MECKLENBURG COUNTY HEALTH DEPARTMENT

APPLICATION FOR PERCOLATION TEST

SITE DISAPPROVAL REPORT
INDIVIDUAL SEPTIC TANK SYSTEM WITH SUBSURFACE, SOIL ABSORPTION, EFFLUENT DISCHARGE

SUBJECT: APT #6079 (John Woodruff)
Windwood Circle, Lot No. 23
7/25/73

APPENDIX H
SITE EVALUATION

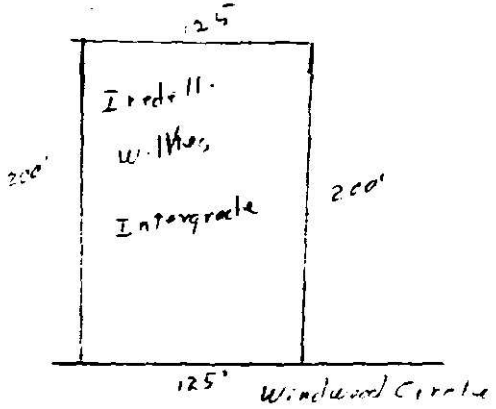
FACTORS	AREA 1	AREA 2	AREA 3	AREA 4
1. SLOPE (%)	(S) PS 6-15% U	S PS U	S PS U	S PS U +
2. SOIL TEXTURE (12-36 in.) (Sandy, loamy, clayey, Note 2:1, Clay)	S 2-1 (PS) Expand. Clay U	S PS U	S PS U	S PS U
3. SOIL STRUCTURE (12.36 in.) (Clayey Soils)	S Mass. Ve PS (U)	S PS U	S PS * U	S PS U
4. SOIL DEPTH (In.)	S Variable PS 18-36" (U)	S PS U	S PS U	S PS U
5. RESTRICTIVE HORIZONS (In.) (Imprevious Strata, Rock)	S Saprol. to PS @ 18-36" (U)	S PS U	S PS U	S PS U
6. SOIL DRAINAGE/GROUNDWATER (External & Internal)	(S) gravel PS water AB 7 46	S PS U	S PS U	S PS U
7. SOIL PERMEABILITY (Percolation Rate)	S (PS) U slow U	S PS U	S PS U	S PS U
8. OTHER (Specify)	S PS U	S PS U	S PS U	S PS U
9. SITE CLASSIFICATION	unsuitable			
SOIL SERIES	Iredell w. Hks, Intergrade

Recommendations/Comments: Lot reinvestigated at request of John D. Woodruff
